RE: 8701 Glendale Ave. NE
Grading & Drainage Plan
Engineer's Stamp Date: 02/06/24
Hydrology File: B20D069

Based upon the information provided in your submittal received 02/28/2024, the Grading & Drainage Plan **is not** approved for Grading Permit. The following comments need to be addressed for approval of the above referenced project:

GRADING & DRAINAGE PLAN

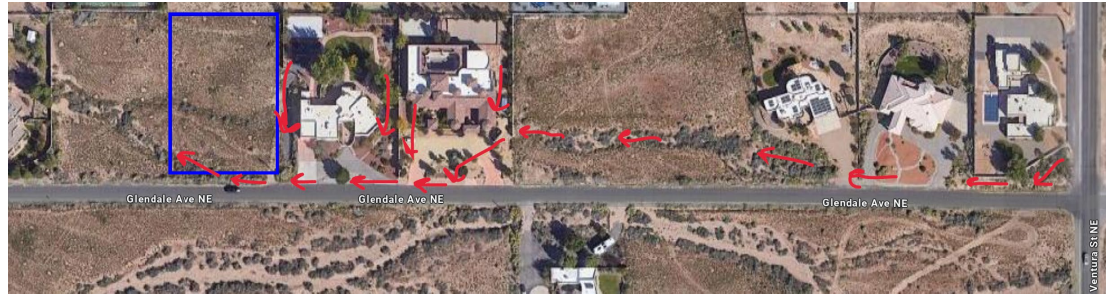
1. Per the IDO, the property owner of the property is responsible for building the adjacent half of Glendale Ave. NE to include curb & gutter, and sidewalk. The project will have to go to the Development Facilitation Team (DFT) for approval of the Infrastructure List. Also, half of an 84" storm sewer (see below) will also need to be added to the Infrastructure List. The storm sewer was called out in the NAA MDP.

2. These improvements will need to be shown on the Grading & Drainage Plan.
3. Please check to make sure that this property doesn't need to be replated as well with the Development Hearing Officer (DHO).

DATE	REVISION	LOT 24, BLOCK 16, TRACT 1 UNIT 3, NORTH ALBUQUERQUE ACRES	
		8701 GLENDALE AVE NE	
		Grading & Drainage Plan	
		FOR LIL BUBBAS CONSTRUCTION	
SIGNED BY: PWC	DRAWN BY: CCE	JOB #: Velasquez_Glendale	C1.0
CHECKED BY: PWC	DATE: FEB'24	FILE # GD - LBC

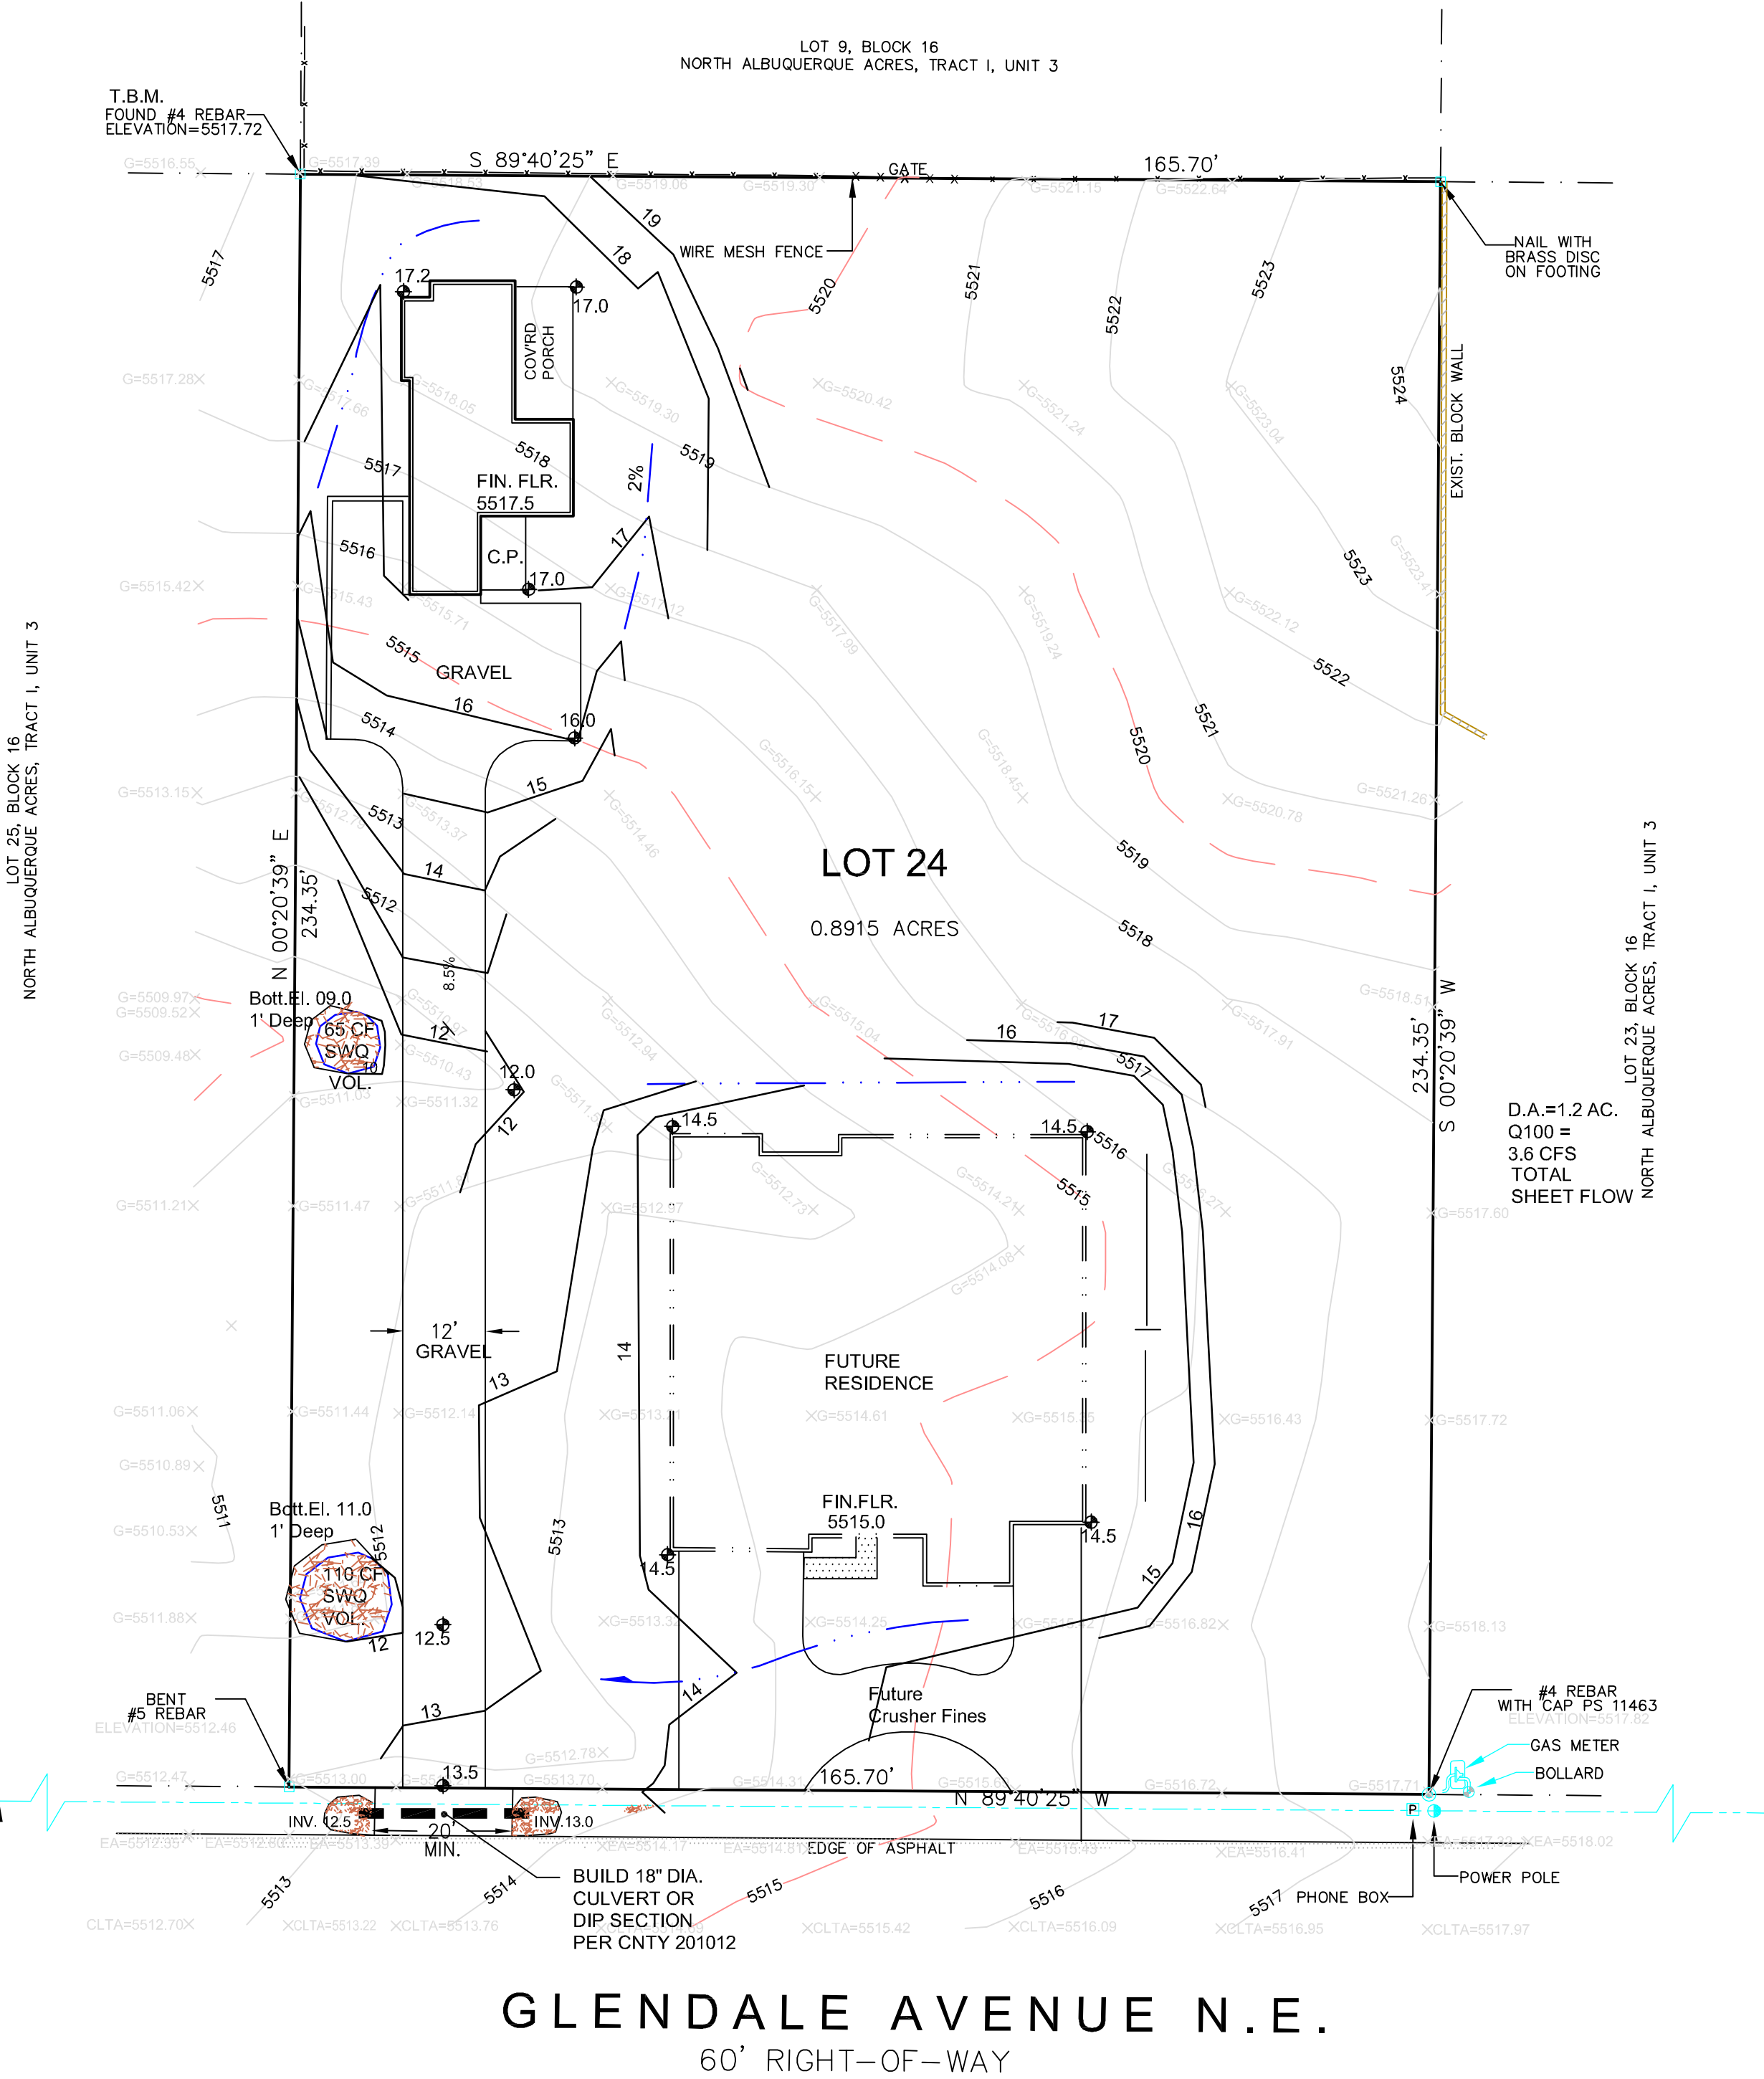
4. Properly showing and calculating the existing drainage that goes in the natural arroyo and Glendale from the east to the west needs to be done. This existing drainage needs to be allowed to go through the property and can be managed somehow in the proposed development.
